RE: Catalyst High School Resubmittal - DR221-0010

We want to assure you that the district continues to work with the consultant team to identify cost savings and value engineering where possible. To that end, I am providing you with revised drawings for the Catalyst High School Project. The changes proposed by the district are clouded on the plans and summarized as follows:

SITE PLAN
SCALE: 1" = 20'-0"

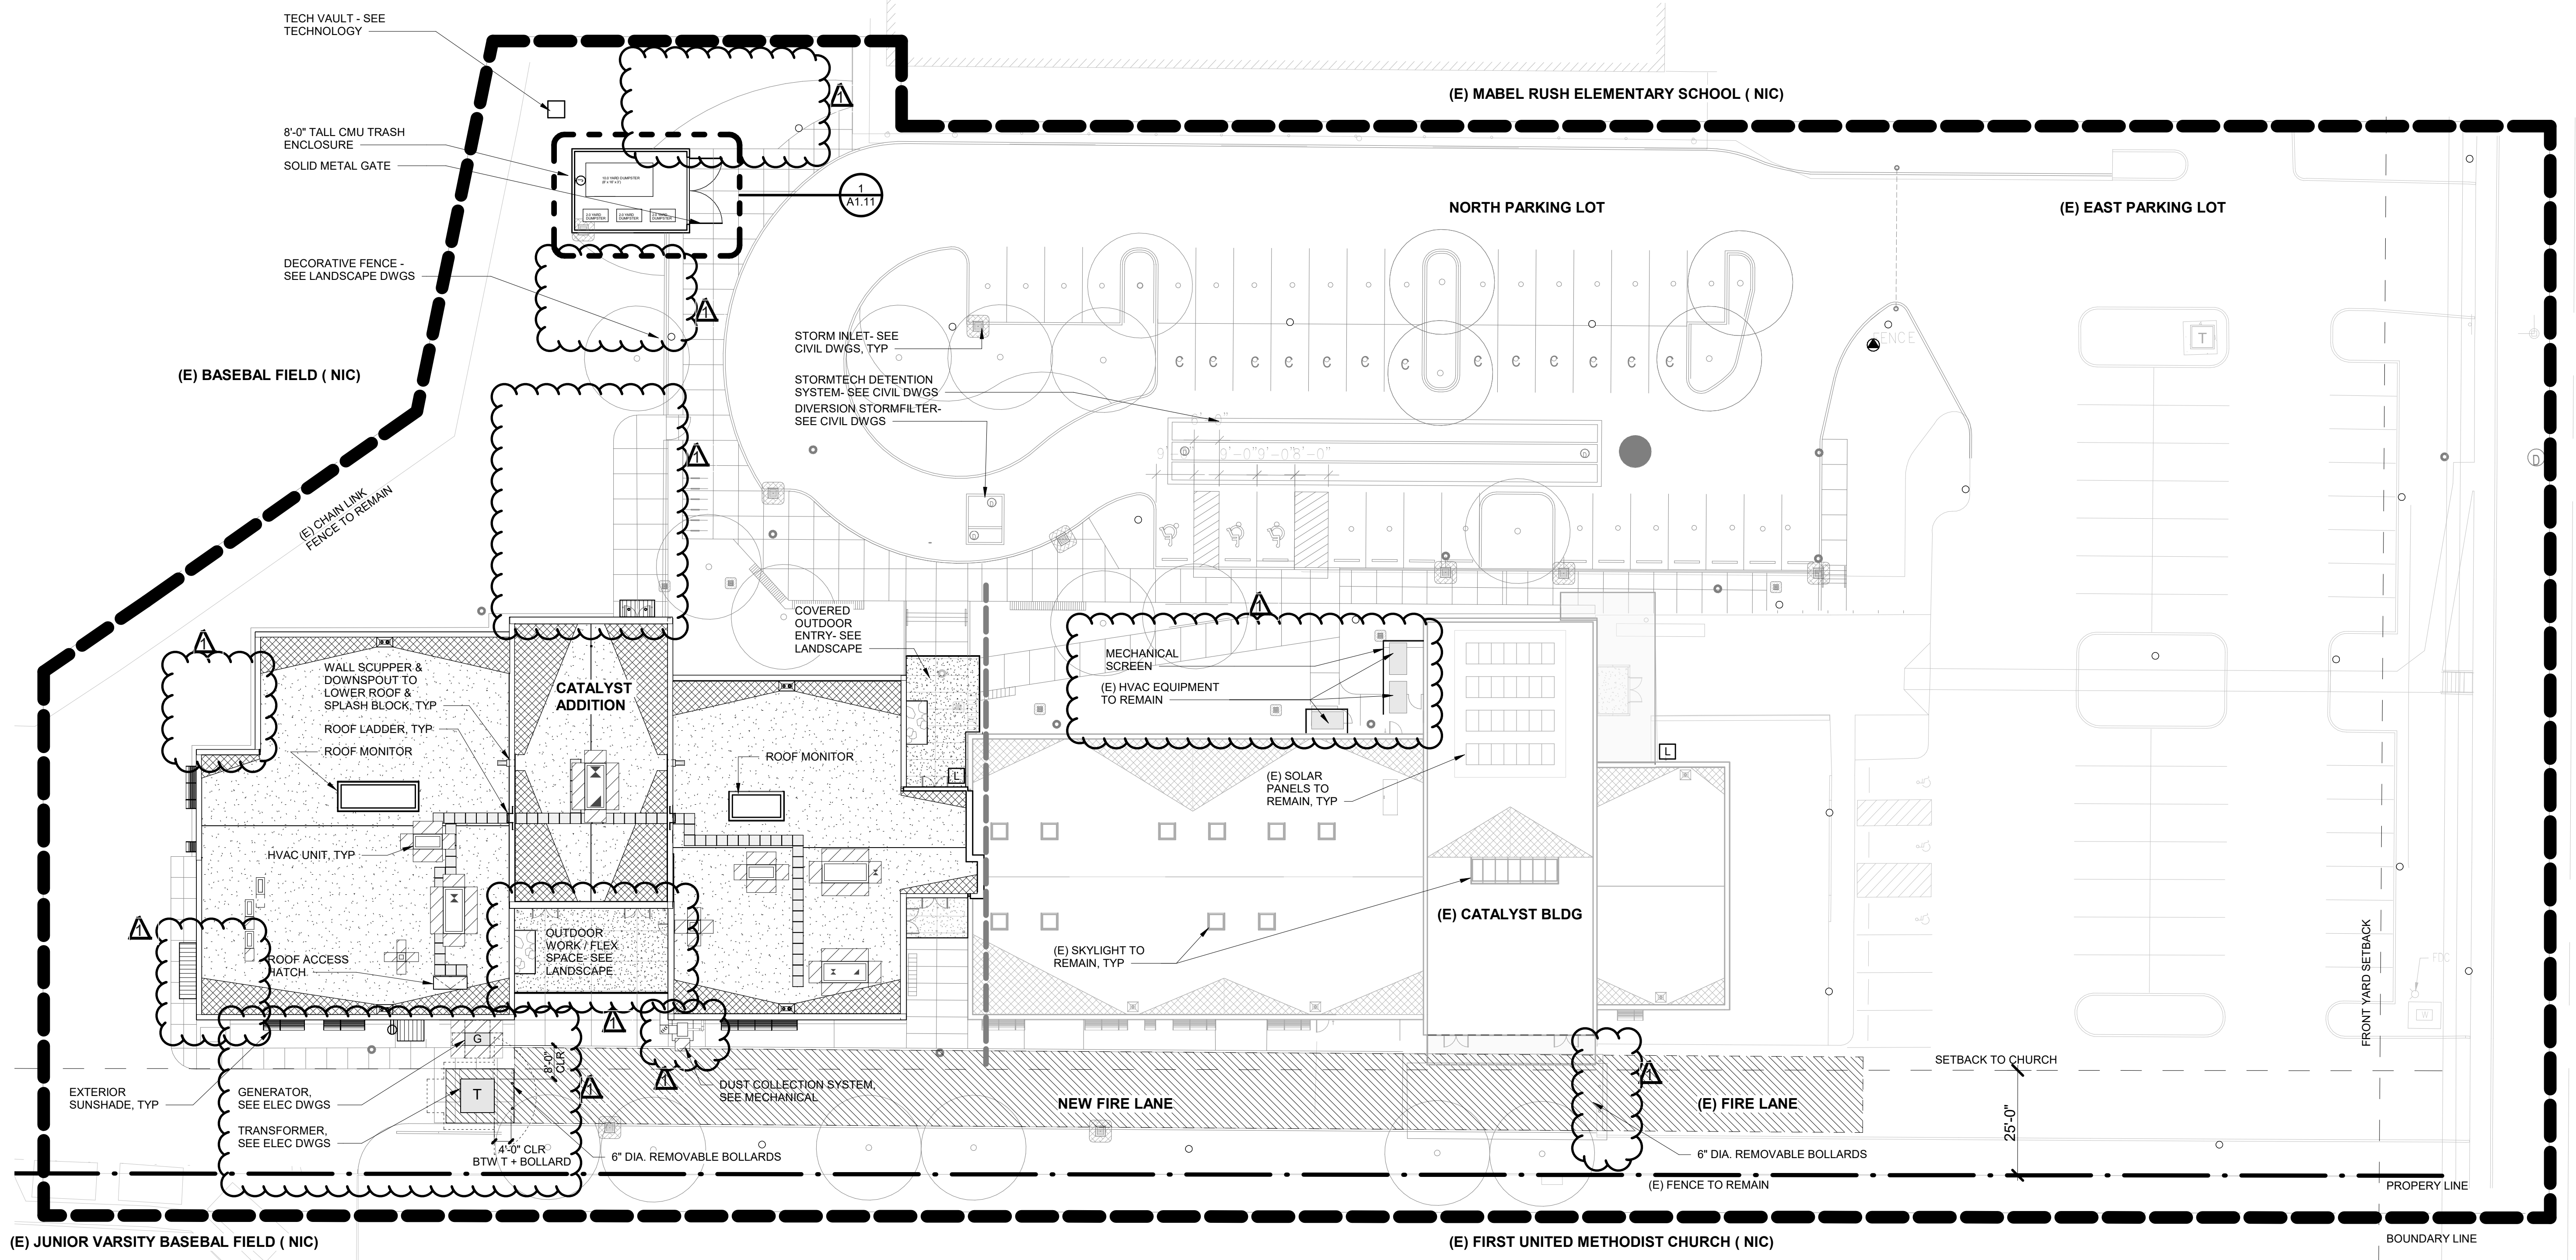
1. The covered play area will no longer be a part of this project. That area will be converted to lawn.
2. The reader board located between the north parking lot and existing east parking lot has been eliminated.

4. The fire gate at the rear of the school will be converted to removable bollards.
5. The generator originally planned to be located next to the trash enclosure will be reduced in size and relocated to the south of the building. It will not be screened.

6. The transformer originally planned to be located next to the trash enclosure was relocated to the south of the building. It will not be screened, but will have removable bollards located adjacent to the fire lane.

7. The gate to the trash enclosure will become a single double gate as opposed to two double gates.
8. The size of the overall building will be reduced to 13,440 square feet in size.

9. The electrical room was moved from the north to the south portion of the building.
10. An exterior dust collection system was located on the south side of the building, adjacent to the fire lane.

11. The north canopy at the Multipurpose room has been reduced down to an over-the-door canopy. The south canopy at the Fabrication Lab was deepened out southward.

EXTERIOR ELEVATIONS

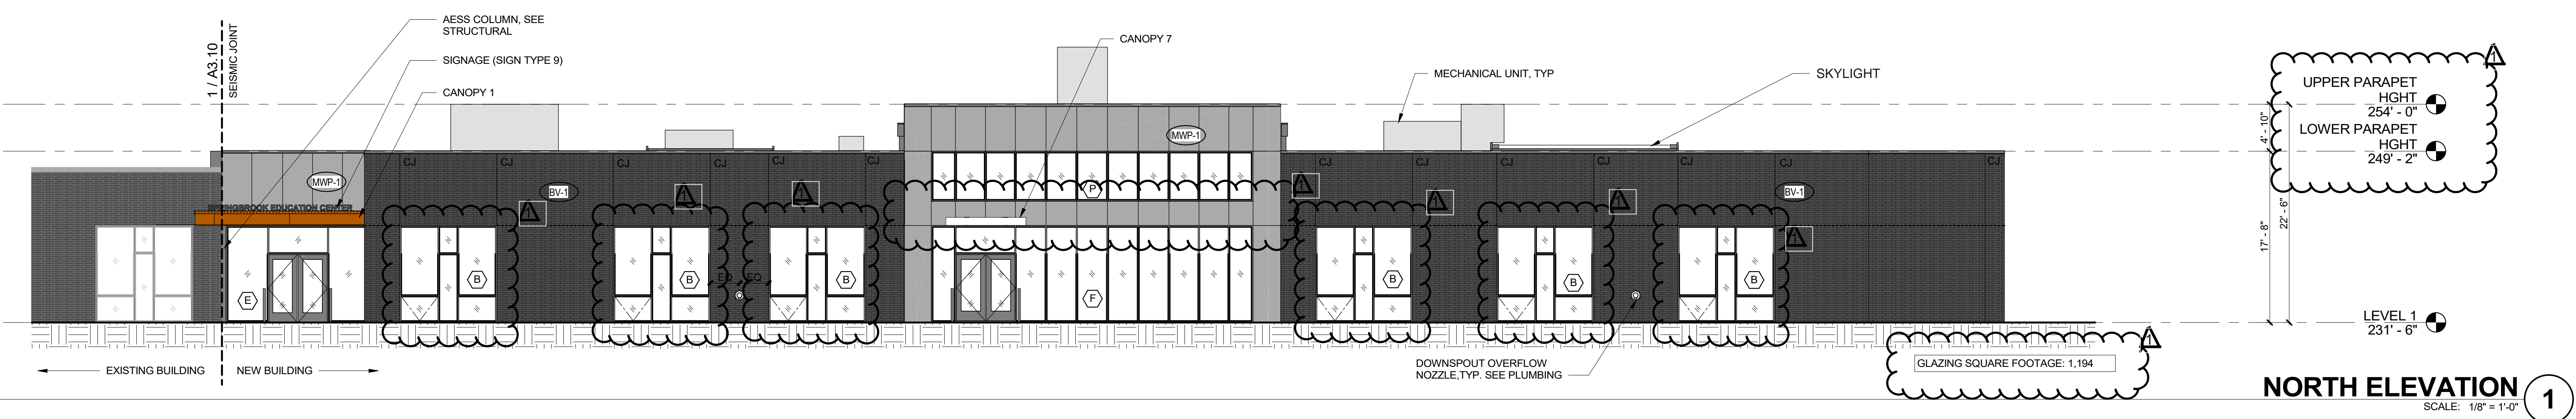
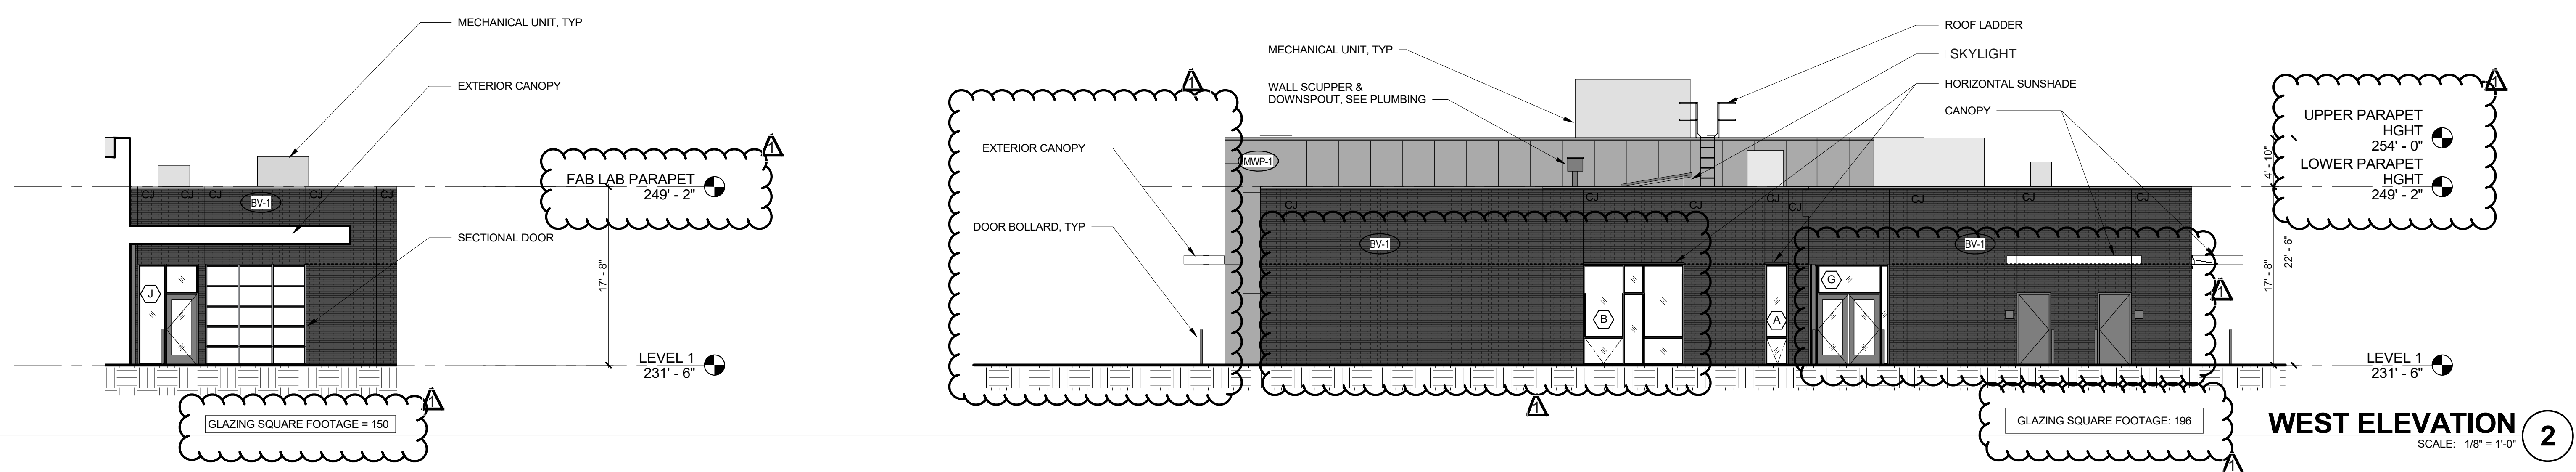
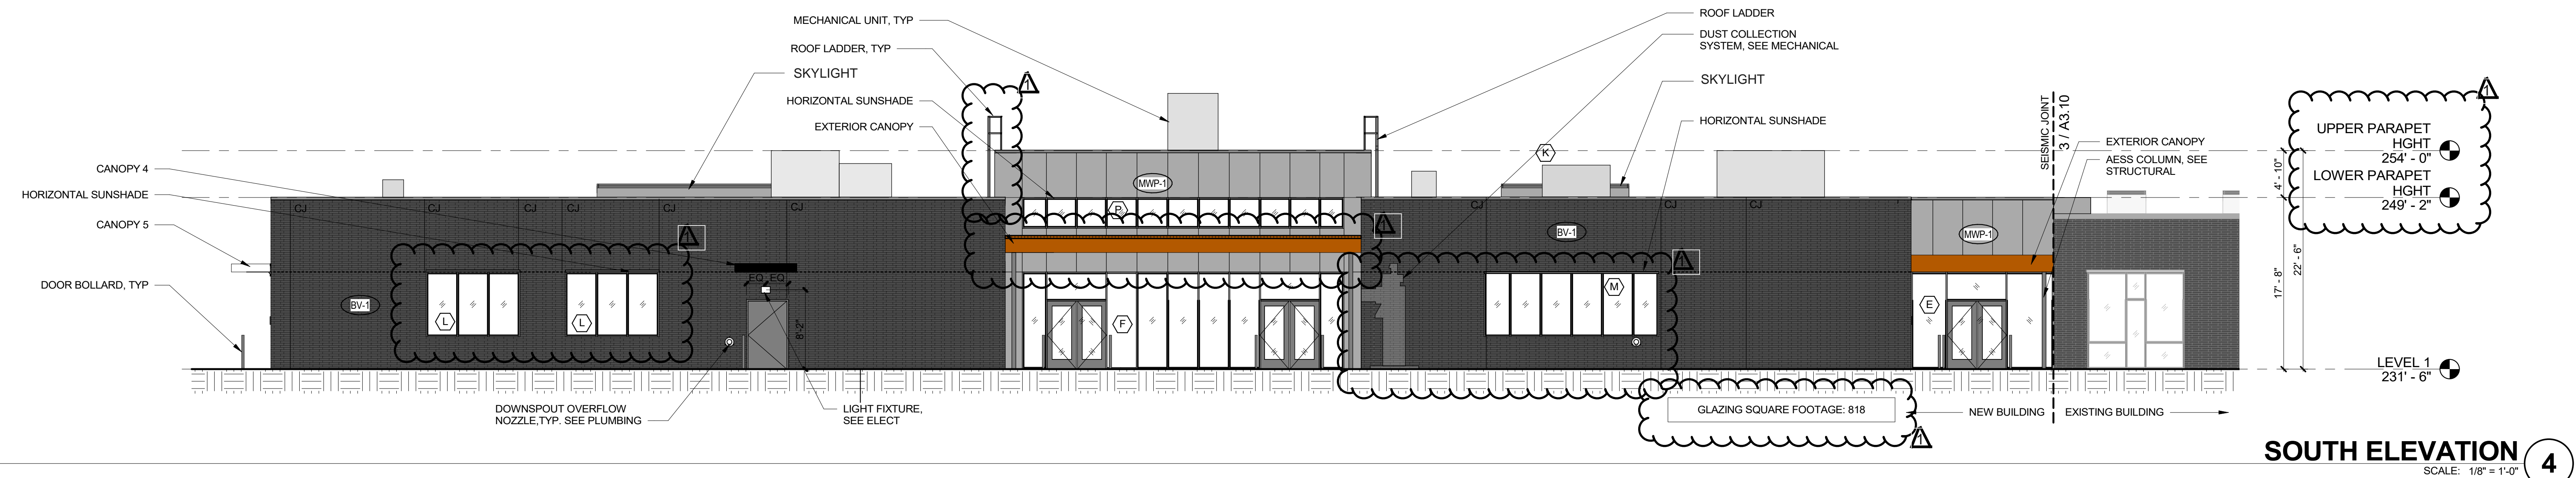
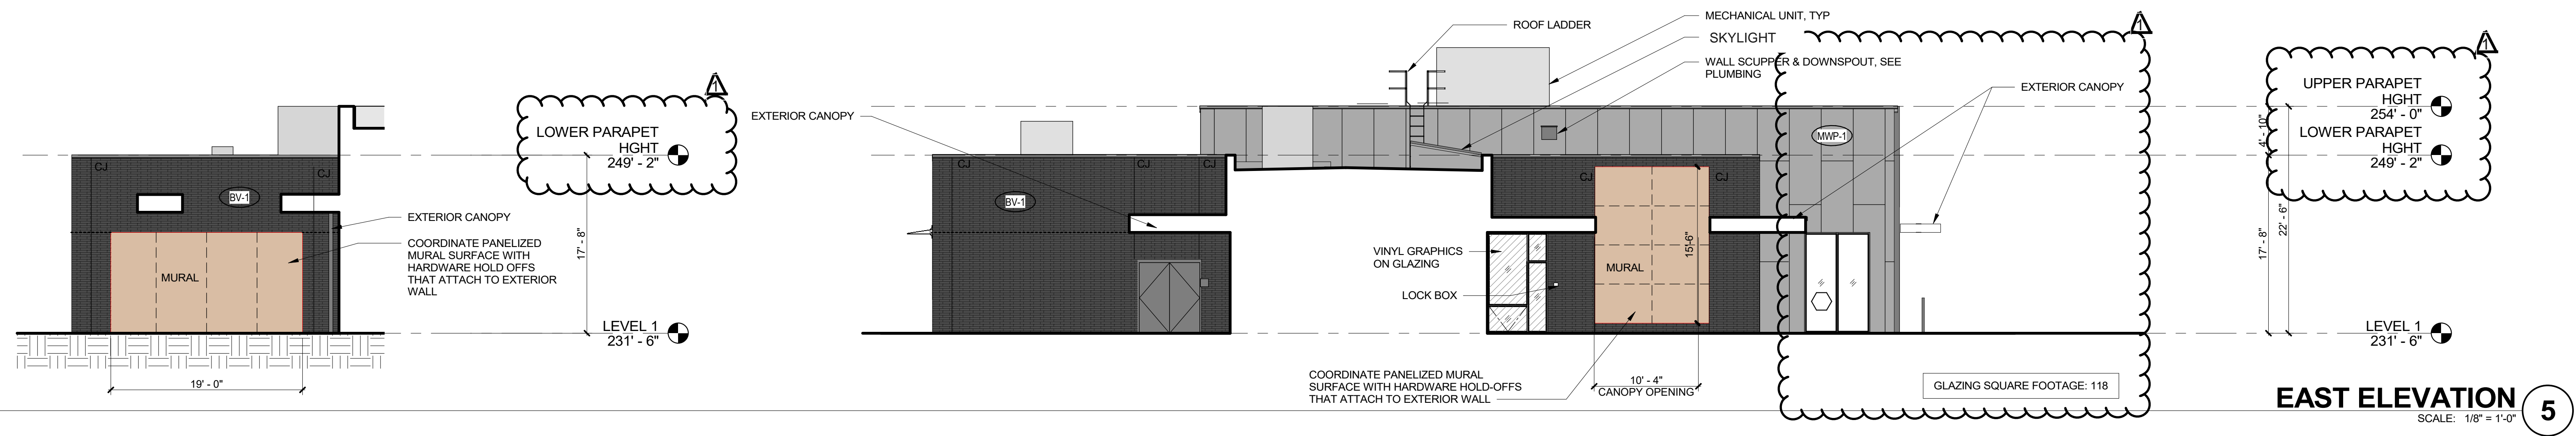
12. The lower parapet height increased to 249'-2", or 17'-8" in height. The upper parapet height decreased to 254'-0", or down to 22'-6" in height. The tallest portion of the building does not go past 22'-6" in height.
13. Roof monitors were replaced with skylights.
14. Window opening sizes were reduced. See exterior elevations for updated glazing square footages.
15. There are no longer any bid alternates associated with this project.
